Conceptual Review Agenda

Schedule for 05/06/13 to 05/06/13

Re: Lot 20, Blk 3, Evergreen Park - Steel Fab. Shop/Self Storage

Description of project: This is a request to use Lot 20, Block 3 Replat Evergreen Park (Parcel # 97013-09-020) as a steel fabrication shop and self-storage facility. Two alternatives have been submitted, including utilizing the lot for both the steel shop and self storage, or utilizing the entire lot for only self-storage. The site is located in the Industrial (I) zone district. Industrial uses and mini-storage facilities are subject to Administrative (Type 1) review in the Industrial zone district.

FIGURE 3-17

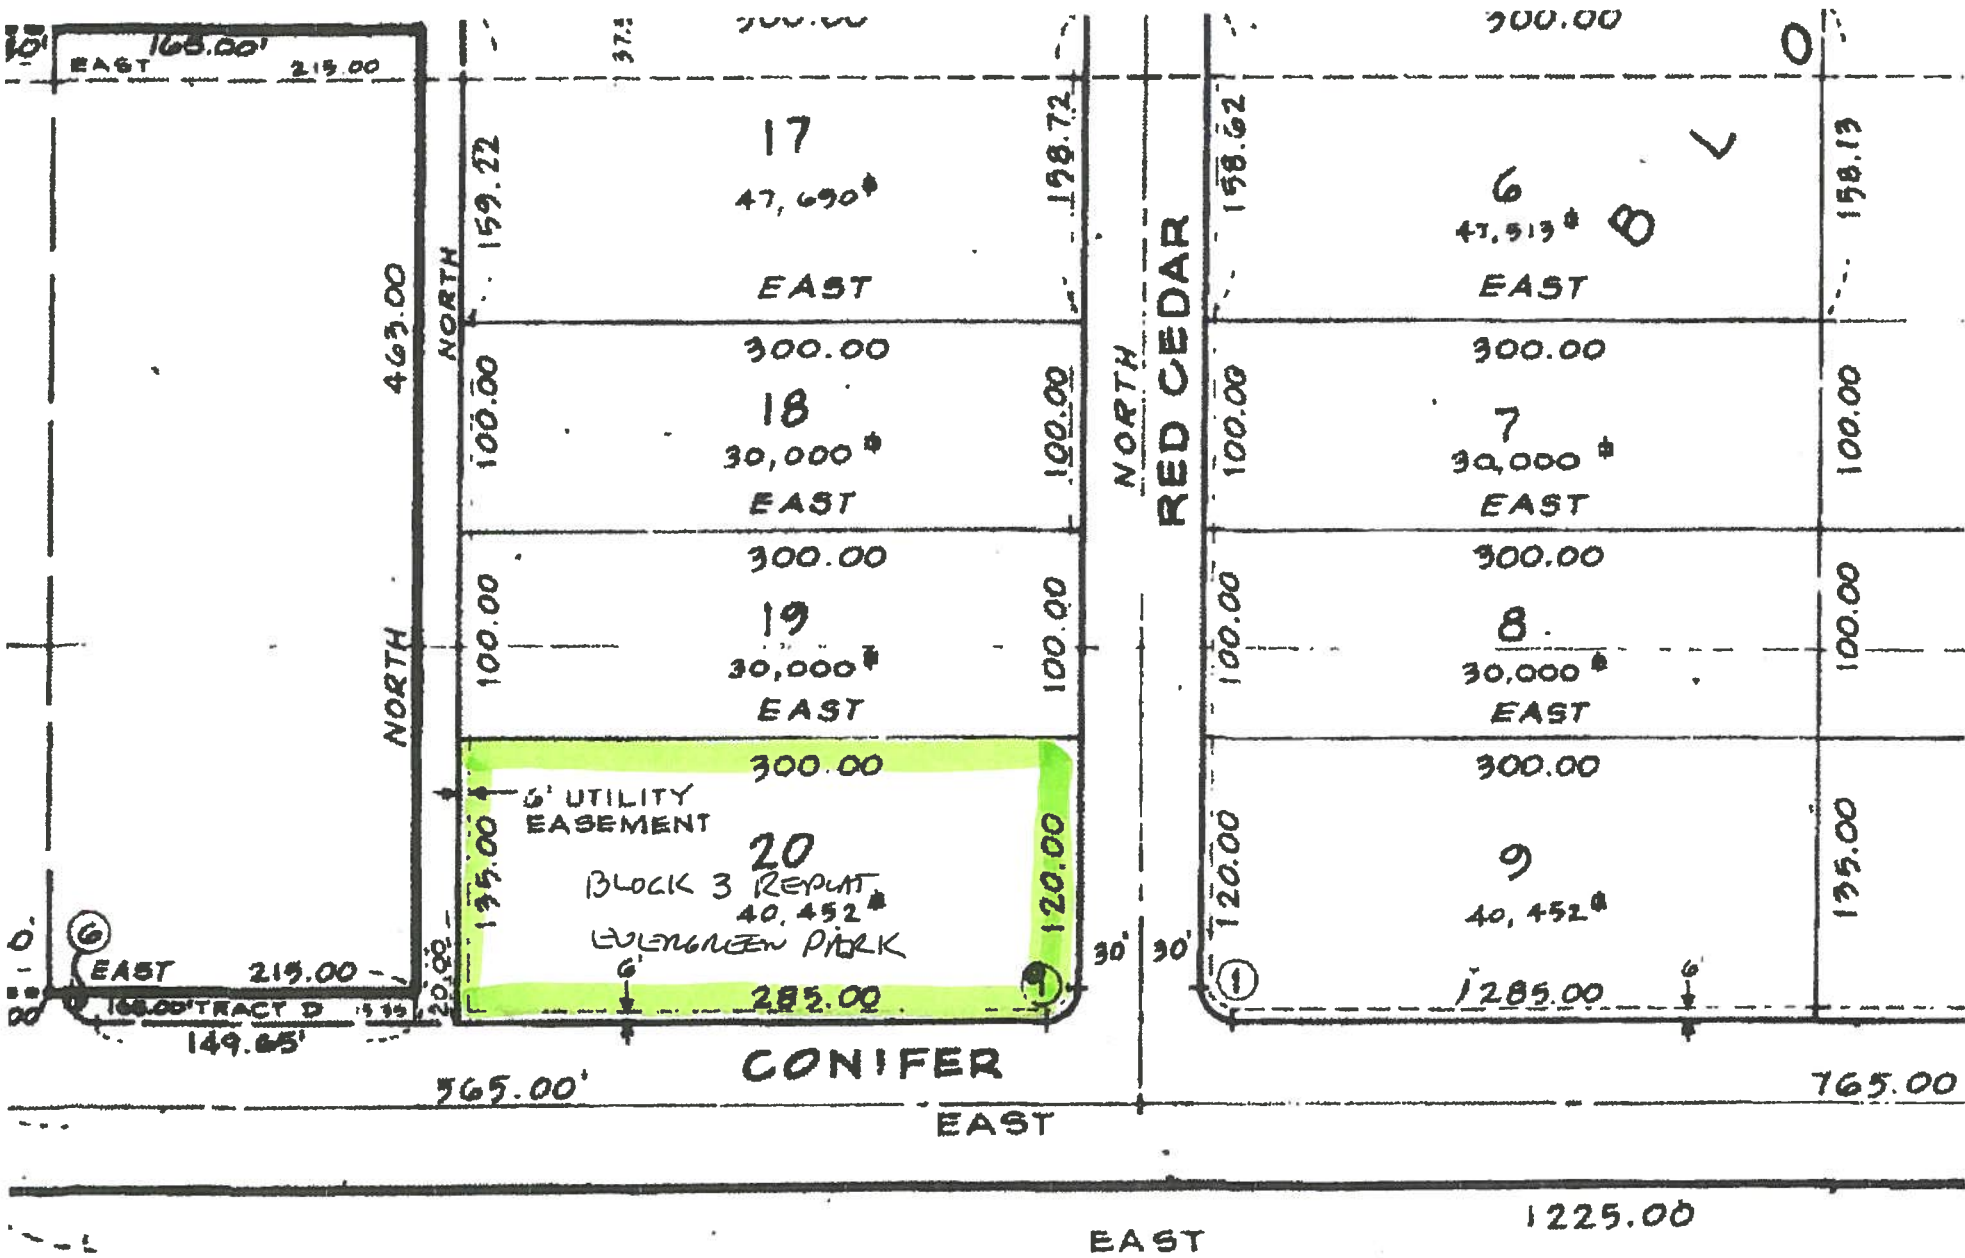
1. The Master Street Plan shows a realignment of the Conifer and Hickory intersection, currently the Master Street Plan shows Conifer shifting north to align to Hickory, potentially through this lot. The North College Ave Access Control Plan also shows this realignment. If the applicant can show how they can accommodate the realignment as part of their development meeting the intent of the Master Street Plan and Access Control Plan, no amendment would be needed. If the applicant desires the realignment not to occur an official amendment to the Master Street Plan would be required. To achieve this a traffic study showing how the street network and traffic would be accommodated would be necessary to support any request for an amendment.

1. The U.S. 287/S.H. 14 Access Management Report along with the City's Master Street Plan identifies that the existing offset between Conifer Street and Hickory Street would be revised to align the two streets in a manner that realigns Conifer Street through the subject property. The proposal would need to accommodate the roadway as part of the site design in order to demonstrate conformance to the Report and Plan, unless these documents were otherwise amended. In order to accommodate the roadway, the site would need to be designed that allowed for the collector roadway to bisect the property with right-of-way dedicated. The roadway would either need to be built to a collector standard (curb & gutter, sidewalks, pavement to collector width and design standards), with reimbursement available through street oversizing for building beyond the local street with, or funds for the local street portion of both sides of the street provided in lieu of construction. Contact Paul Sizemore, FC Moves Program Manager at 224-6140/psizemore@fcgov.com for additional information on the Report and Plan documents. The remaining comments are standard comments with development, with additional comments possible as the roadway alignment is addressed.

1. This project is in conflict the North College Access Control Plan as well as the Master Street Plan. The project will need to re-submit for conceptual review showing Conifer going through the parcel as shown on the North College Access Control Plan or amendments will need to be made to the Master Street Plan and the North College Access Control Plan.

ALTERNATIVE A

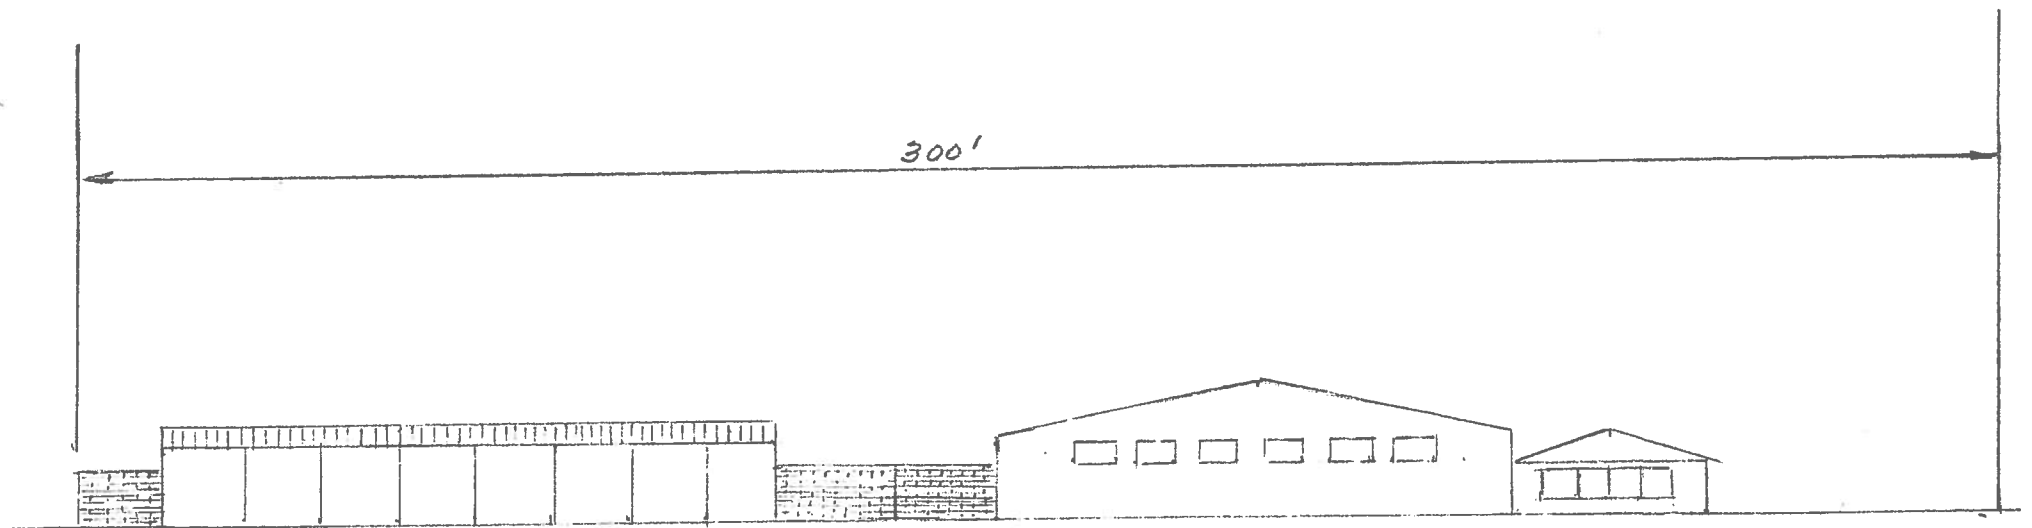
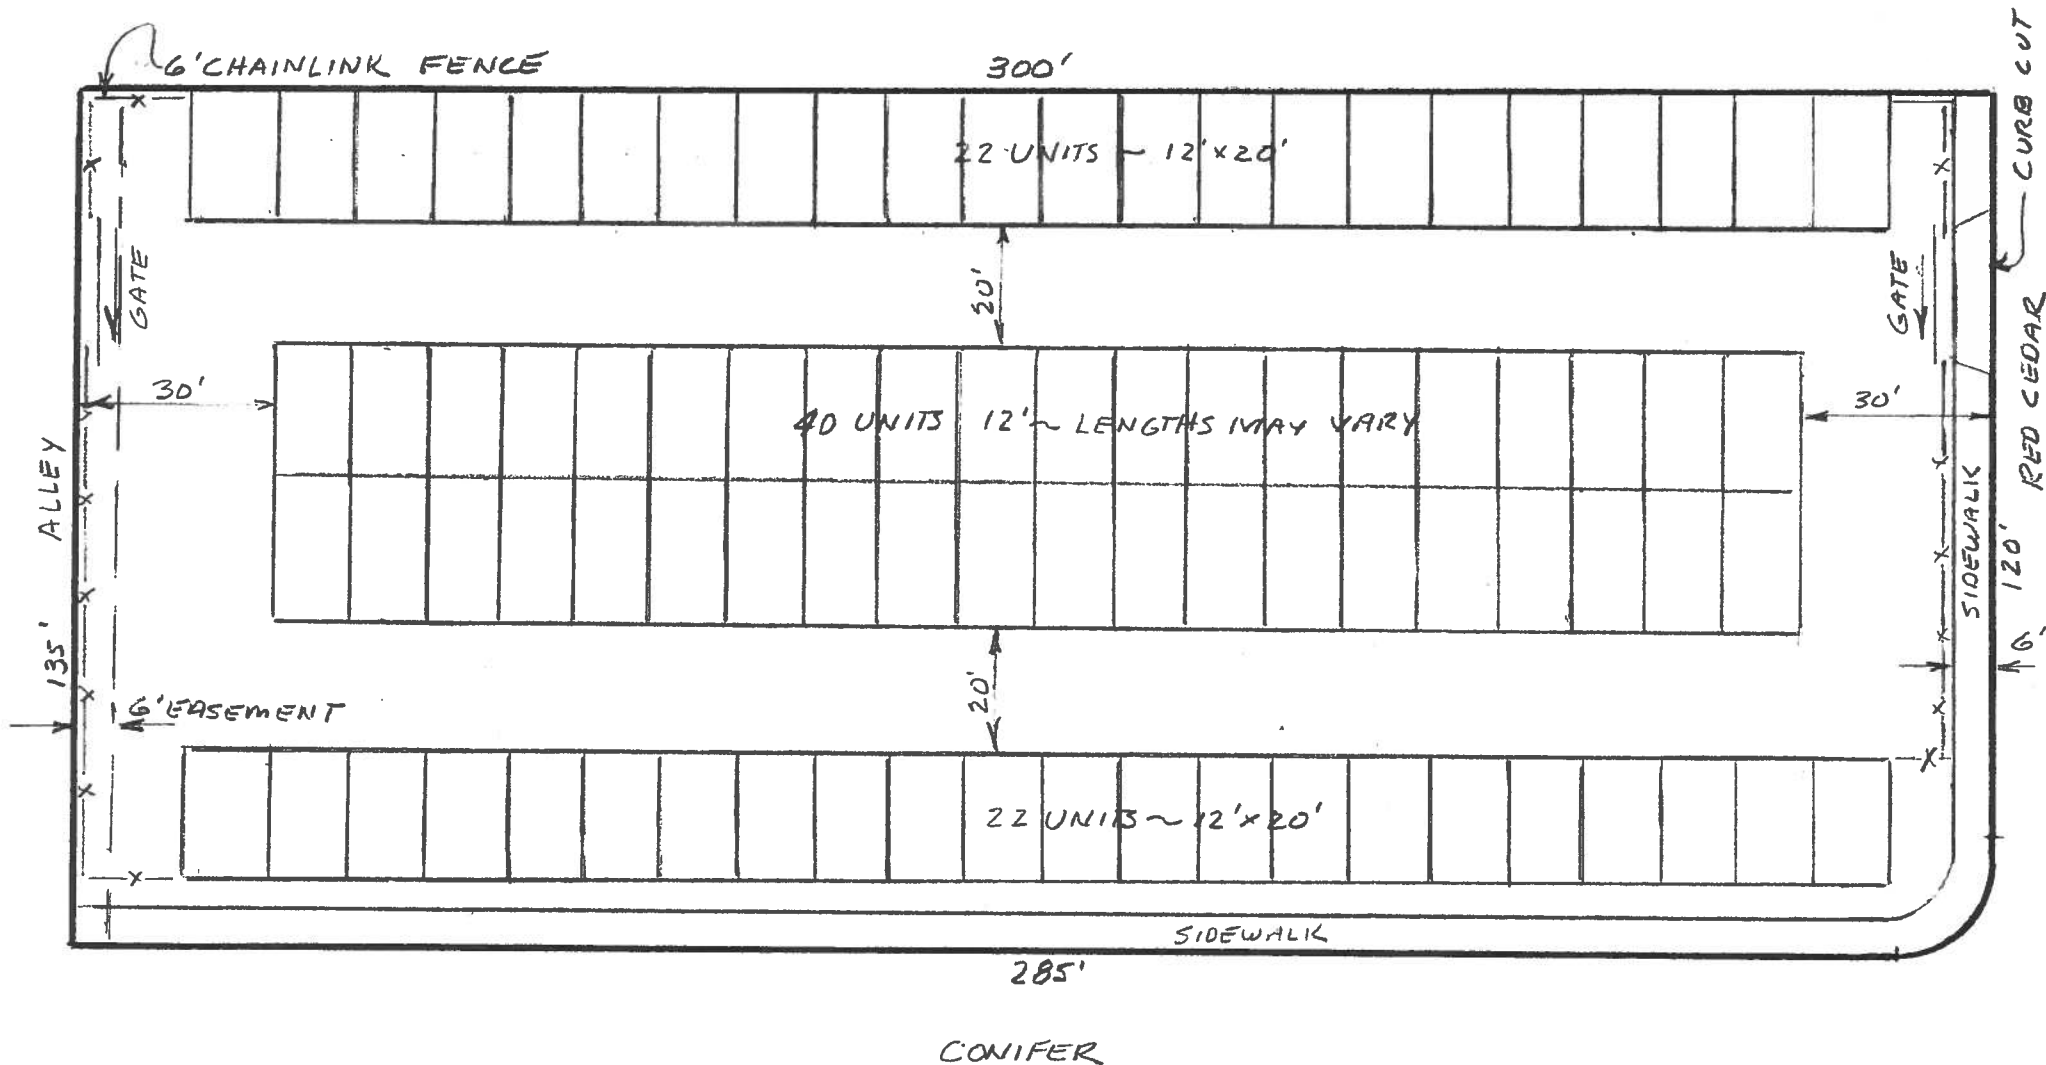
This means there is a required 30ft landscape yard along Conifer St.

Screening is required along Conifer, Red Cedar and the Alley (Chain Link fence is prohibited for screening material).

The current plan renders the building and storage units out of access. A fire lane on the property shall be required to serve all buildings, including the self-storage units.

HARMONY TECHNOLOGY PARK THIRD FILING, SECOND REPLAT
FORT COLLINS, COLORADO
EXISTING & CONCEPTUAL UTILITY PLAN EXHIBIT

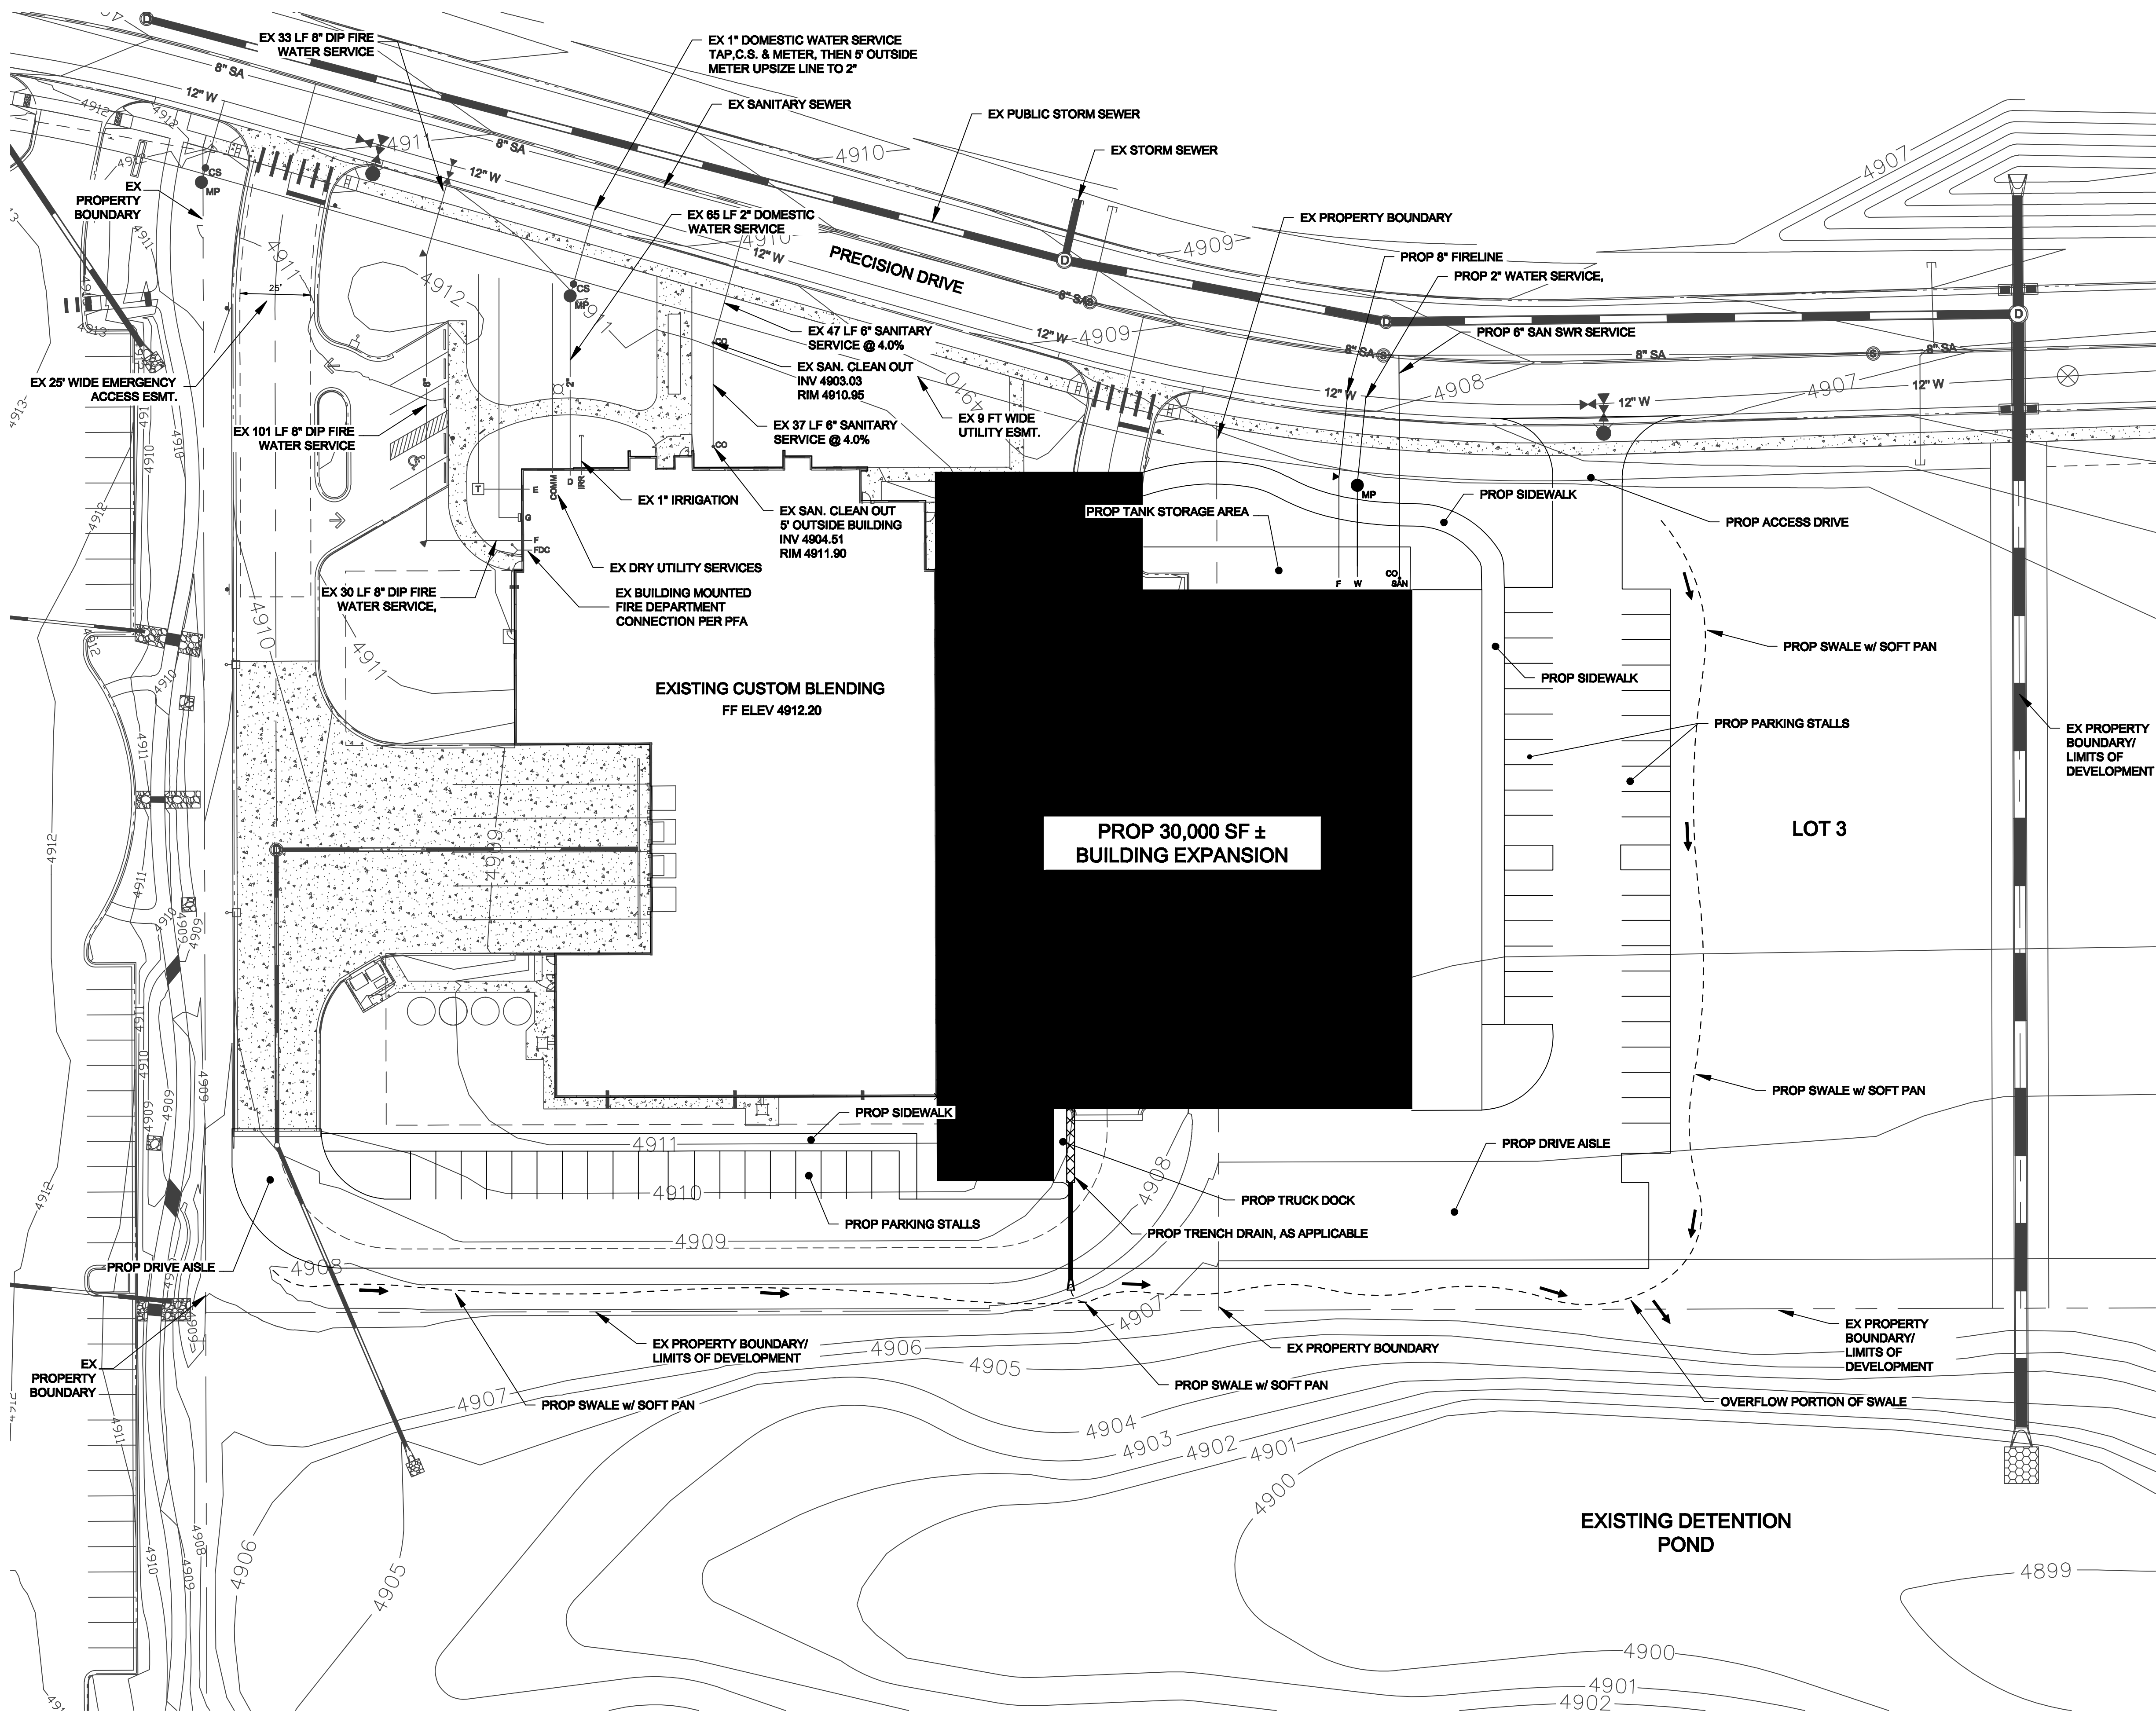
2. The runoff detention was designed and built with the previous phase of Custom Blending so the design engineer will need to verify in the drainage report that the proposed development is in compliance with the Harmony Technology Park overall drainage plan. In particular the impervious percentage of the proposal and that drainage patterns are consistent with the plan.

The existing Emergency Access Easement on the west side of the facility shall be extended so as to also provide for a fire lane on the south and east sides of the current and expansion buildings. The EAE shall meet fire lane specifications outlined in Chapter 5 of the 2006 IFC (specifically sections 503.2.3, 503.3, 503.4).

6. The existing driveway approach over where the expansion occurs would need to be removed and replaced with sidewalk, curb and gutter and landscaping in right-of-way. The new driveway approach would need to be built to City standards (the existing drive approach to be removed was built with asphalt in the right-of-way and should have been constructed in concrete to the property line per standard LCUASS detail 707.)
